SERVICE BULLETIN

SUBJECT: ELECTRICAL POWER – Modification of Static Inverter Part Number 1-002-0102-2173 to Part Number 1-002-0102-2573.

TRANSMITTAL: Service Bulletin 1-002-0102-2573-24-44 Initial Release (Revision 0).

1-002-0102-2573-24-44

Figure 21

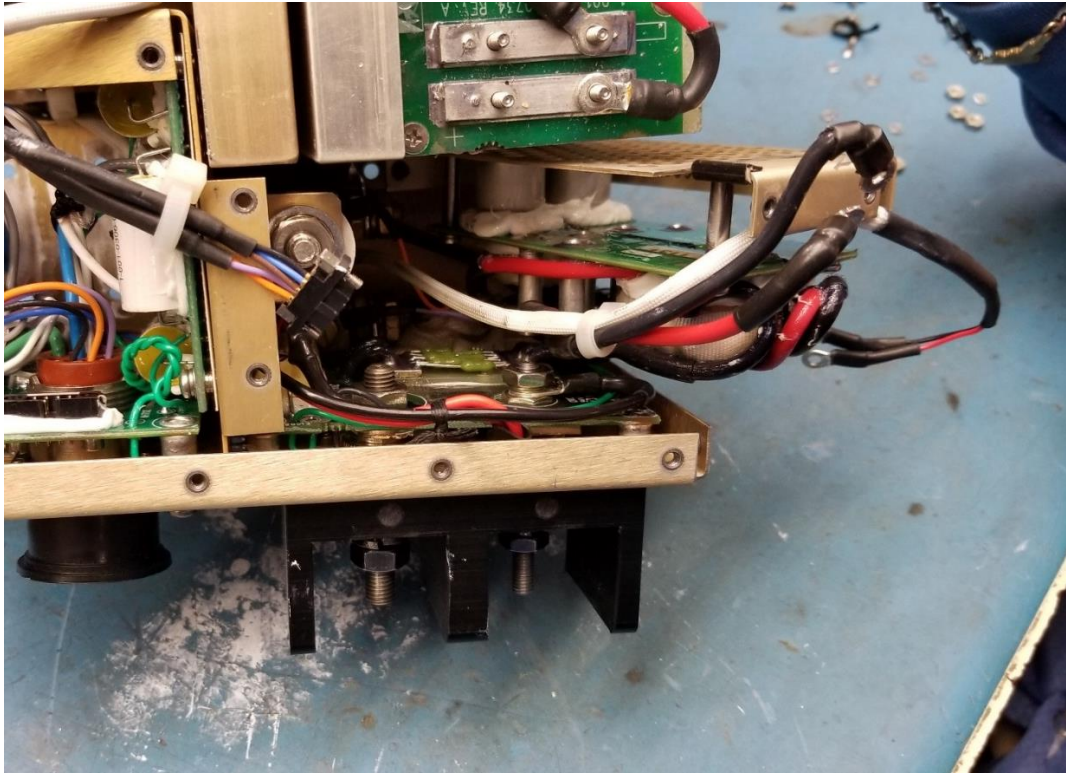
22. Carefully move the PCB EMI Input/Bracket assembly over to access the area where the capacitor is located. (Figure 21).
23. Remove (1) nut (25082-C4), (1) washer (1-001-3201-0084), and (1) washer (1-001-3202-0073) from the diode assembly. (Figure 22).

Figure 22

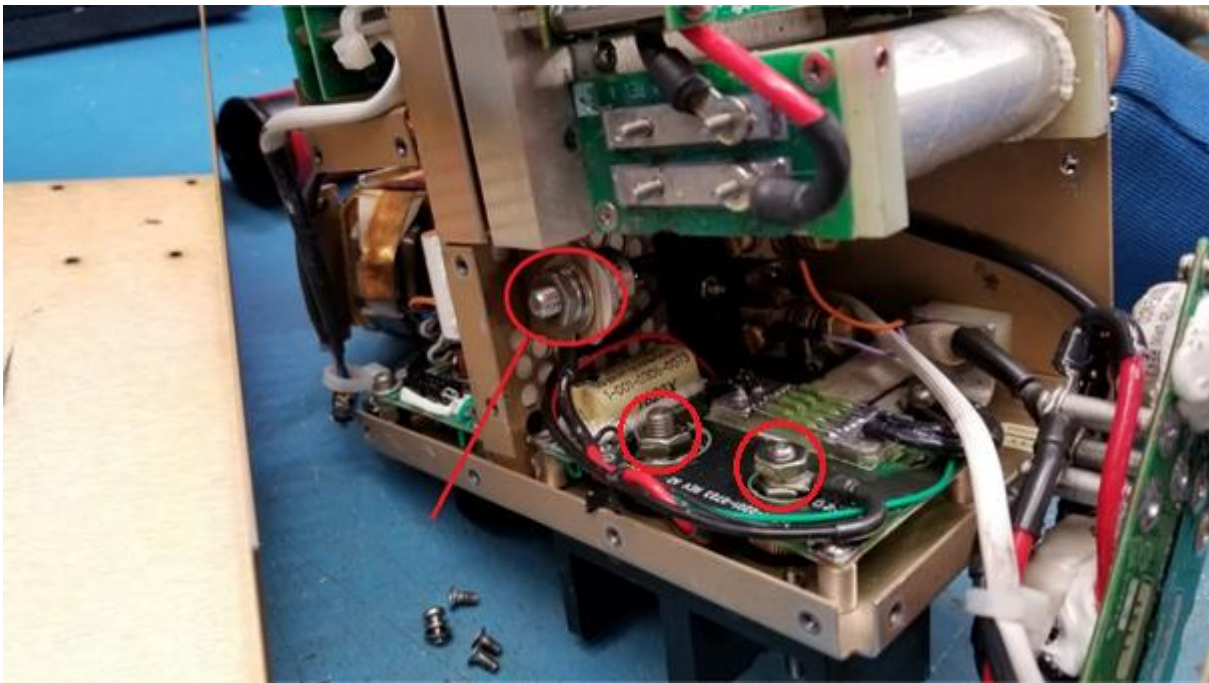
24. Remove (1) nut (35650-304), (1) nut (35650-3254), (1) washer (35338-138), (1) washer (35338-139), and (1) washer (15795-809). (Figure 22).
25. Remove (4) screws (51957-16) from the terminal block assembly and (3) screws (51957-13), and (1) screw (24693-C2) from the front panel. (Figure 23).
26. Remove (1) nut (35650-304), (1) nut (35650-3254), (1) washer (35338-138), (1) washer (35338-139), (1) washer (15795-808), and (1) washer (15795-809) from the studs of the terminal block. (Figure 23).
27. Soften the RTV around the capacitor and remove it by cutting the leads with a cutter. (Figure 22).
28. Remove excess capacitor leads soldered to the PCB using solder wick and soldering iron set at 650F.

35. Reinstall (1) nut (35650-304), (1) nut (35650-3254), (1) washer (35338-138), (1) washer (35338-139), and (1) washer (15795-809). (Figure 22).
36. Reinstall (1) nut (35650-304), (1) nut (35650-3254), (1) washer (35338-138), (1) washer (35338-139), (1) washer (15795-808), and (1) washer (15795-809) to the studs of the terminal block. (Figure 23).

Figure 23

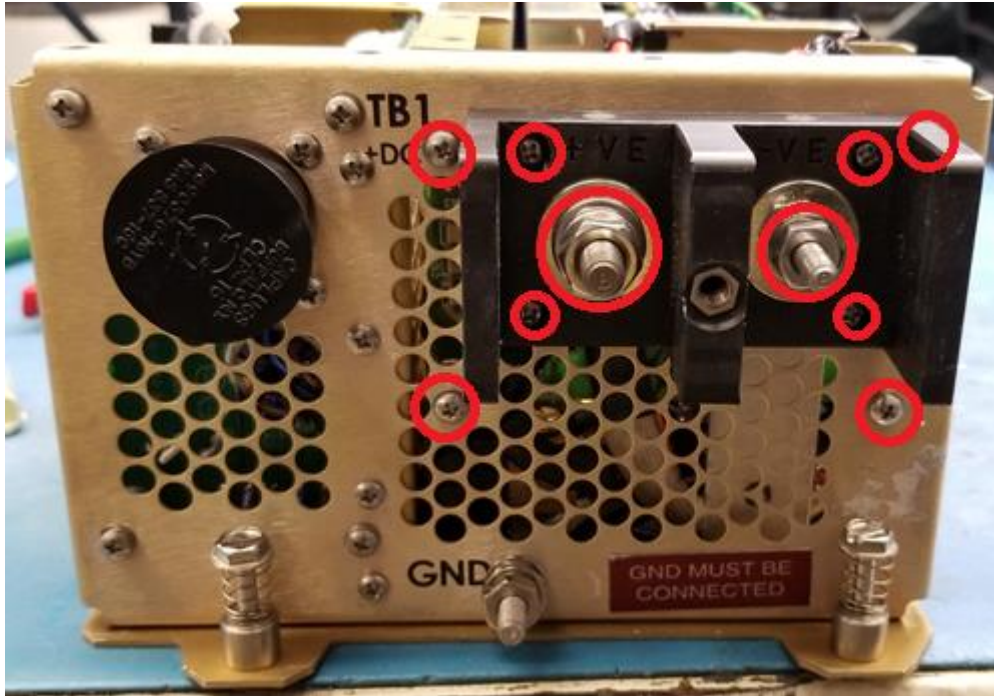
37. Reinstall (4) screws (51957-16) to the terminal block and (3) screws (51957-13), and (1) screw (24693-C2) to the front panel. (Figure 23).
38. Reinstall (1) nut (25082-C4), (1) washer (1-001-3201-0084), and (1) (1-001-3202-0073) to the diode assembly. (Figure 27).

Figure 24

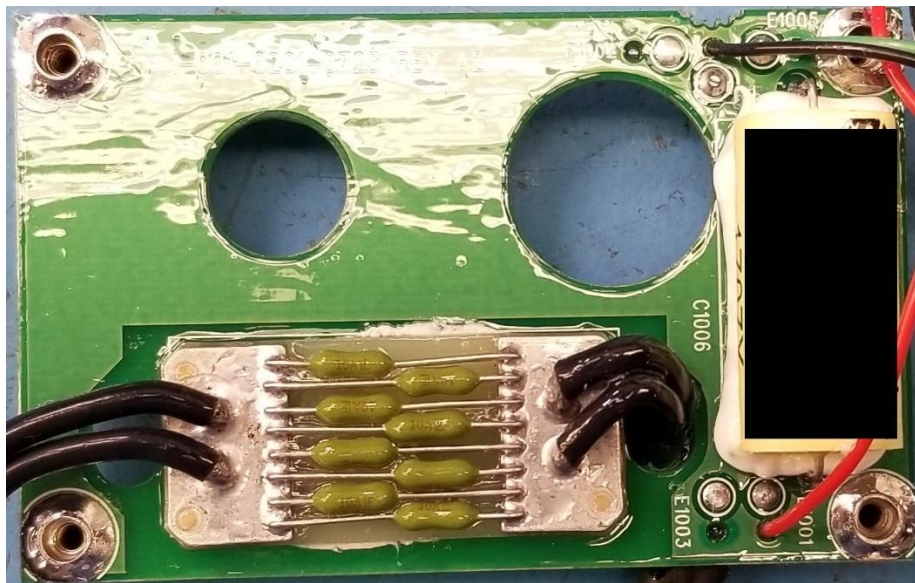
34. On the reverse side of the DC connector assembly, place the (2) new labels (1-001-2503-0001) which show the new part number of the assembly (1-002-0108-0394), manually brush areas with conformal coating (MIL-I-46058) (label in red area) (Figure 24, Figure 25).

Figure 26

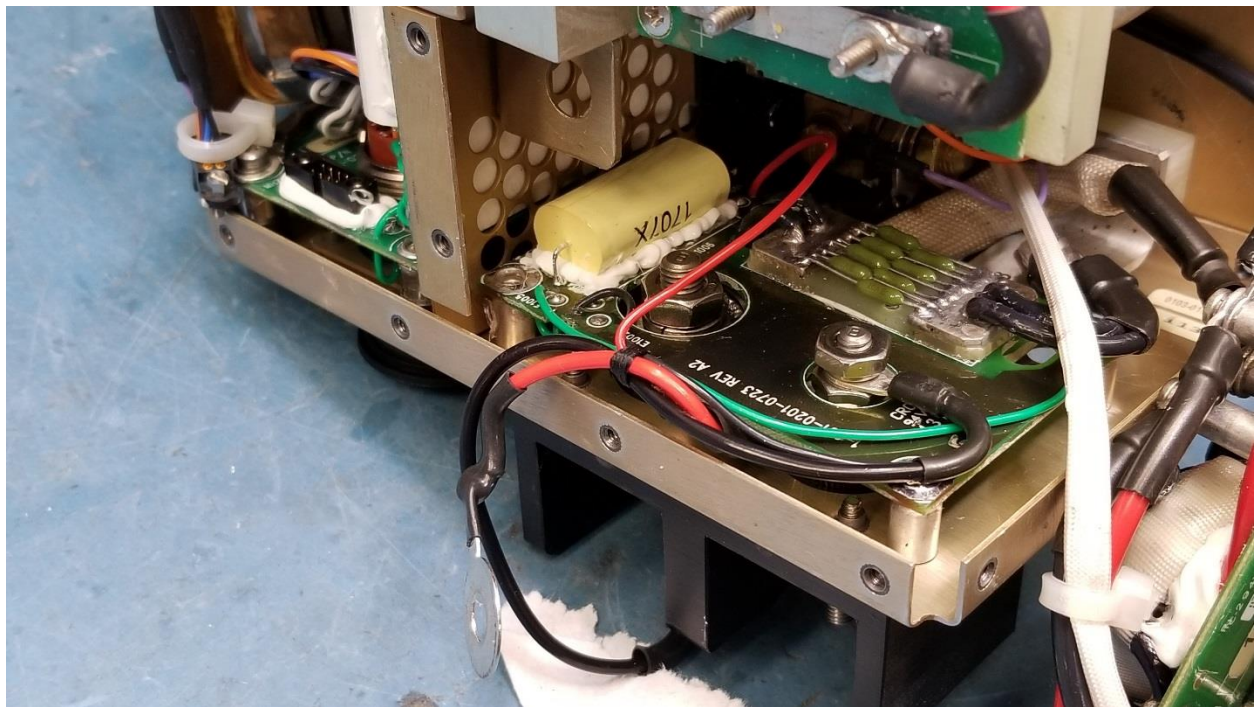
31. Apply thinner (1-001-2302-0019, T521-5L) over the old RTV and peel it off after 5 mins of dwell time.
32. Install and solder the new capacitor (1-001-0306-0151). (Figure 26).

Figure 28

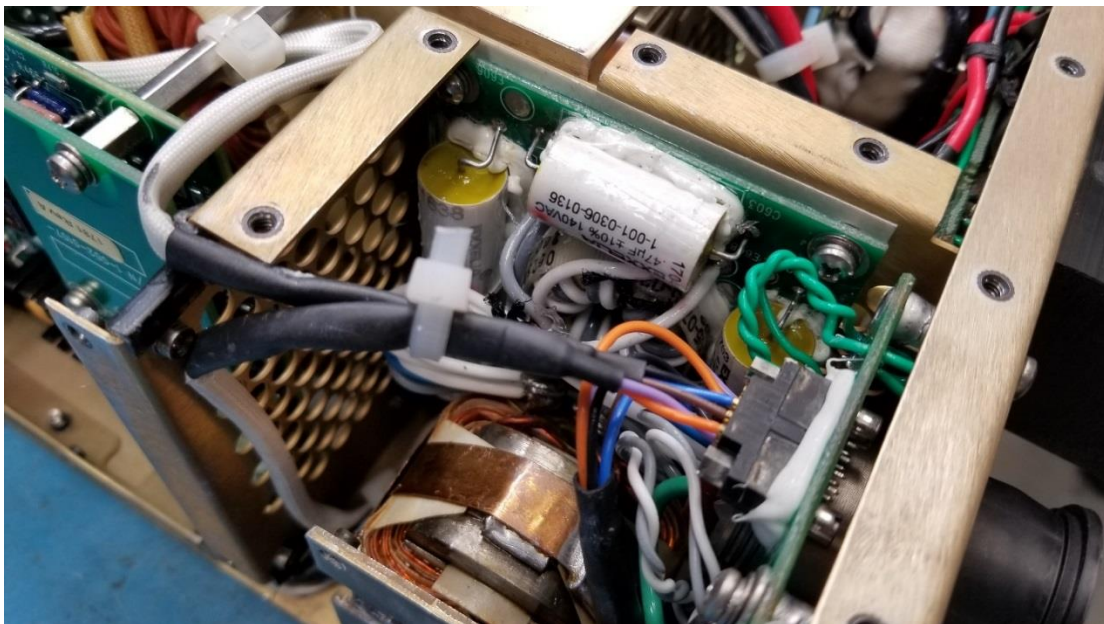
44. Secure the wires with grommet (1-001-0204-0029, Type 6/6). Secure the cables with cable tie (MS3367-5-9). (Figure 28, Figure 29)
45. Reinstall the top cover of the unit by inserting (48) screws (51957-12) into the unit. (Figure 1, Figure 2).
